ECR#: U1

Title: microATX MB to I/O aperture, correct the dimension, and text.

Spec. Version: microATX Motherboard Interface Specification V1.0

Figure 4: Chassis I/O Aperture Requirements

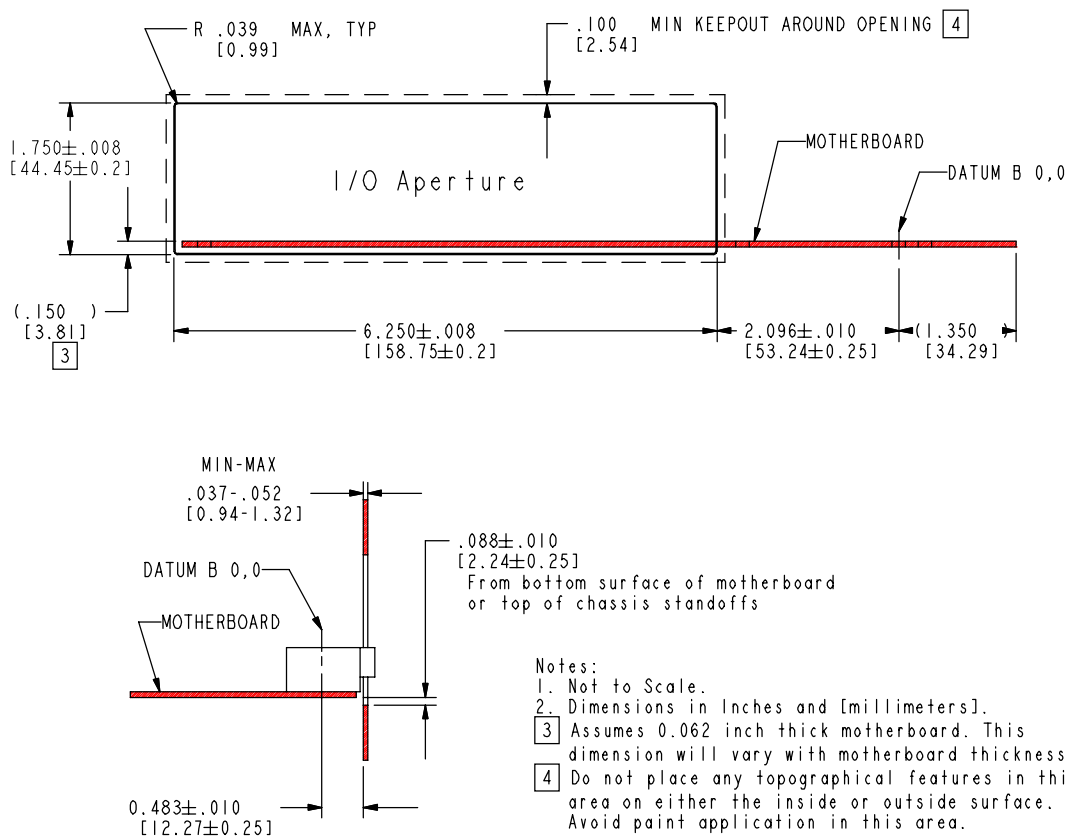
The dimension between the bottom of the motherboard to bottom of the chassis I/O opening needs to be corrected in Figure 4. The hatched area description for Figure 5 needs to be corrected.

Replace Figure 4 with the new figure provided here. (0.088 – .010 was 0.086 – .010)
